V2500-A5 PROPULSION SYSTEMS SERVICE BULLETIN

ENGINE – FUEL AND CONTROL – CONTROL, ELECTRONIC ENGINE – REPLACEMENT OF THE CHANNEL A
INTERCONNECT CIRCUIT CARD ASSEMBLY

ENGINE FUEL AND CONTROL - EEC150-40 ELECTRONIC ENGINE CONTROL - CHANNEL TO CHANNEL CONNECTOR

EEC150-40-73-24

LOCATION OF THE ELECTRONIC ENGINE CONTROL
73-22-34
FIGURE 1

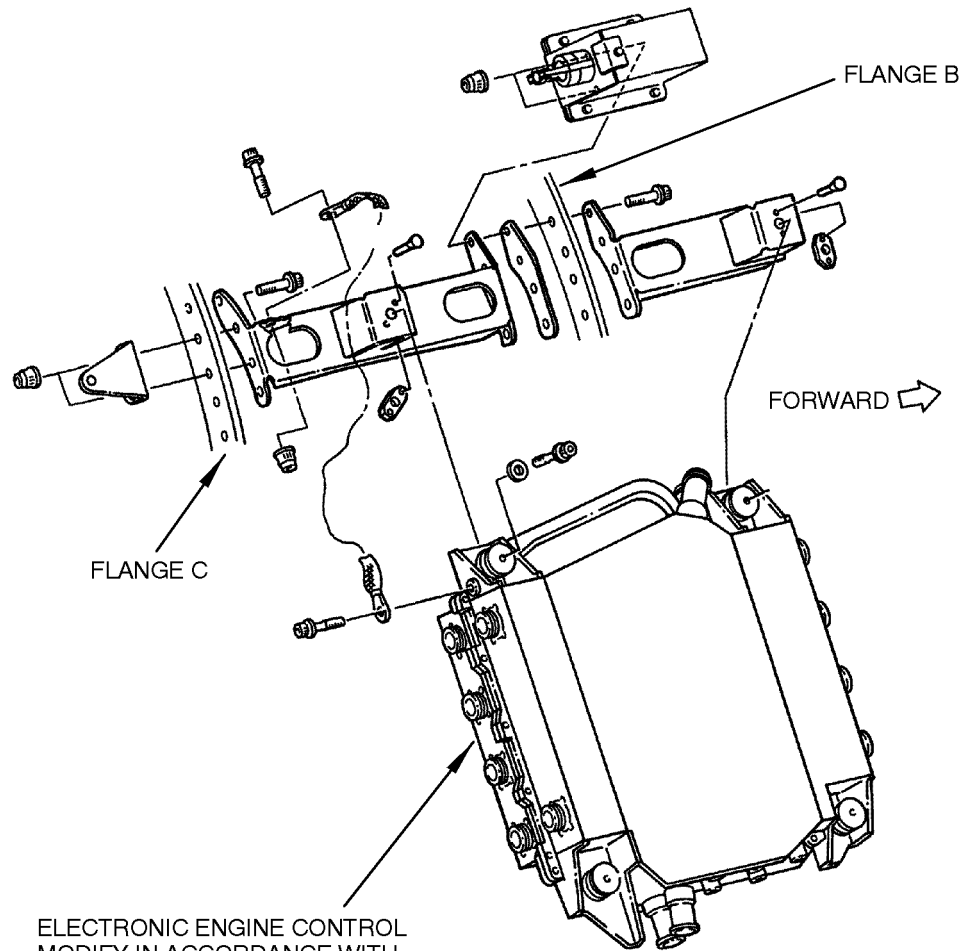
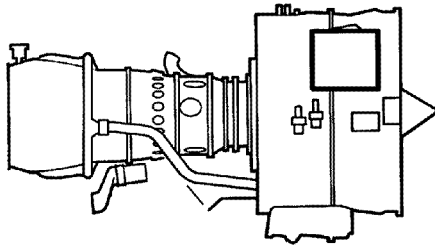
- (1) Modify your Electronic Engine Control (EEC) in accordance with Reference 1, Hamilton Sundstrand Service Bulletin No. EEC150-40-73-24. See Figure 1 for the location of the EEC.
- (2) Recording Instructions
 - (a) A record of accomplishment is required.

ELECTRONIC ENGINE CONTROL
MODIFY IN ACCORDANCE WITH
REFERENCE 1, HAMILTON SUNDSTRAND
SERVICE BULLETIN NO. EEC150-40-73-24
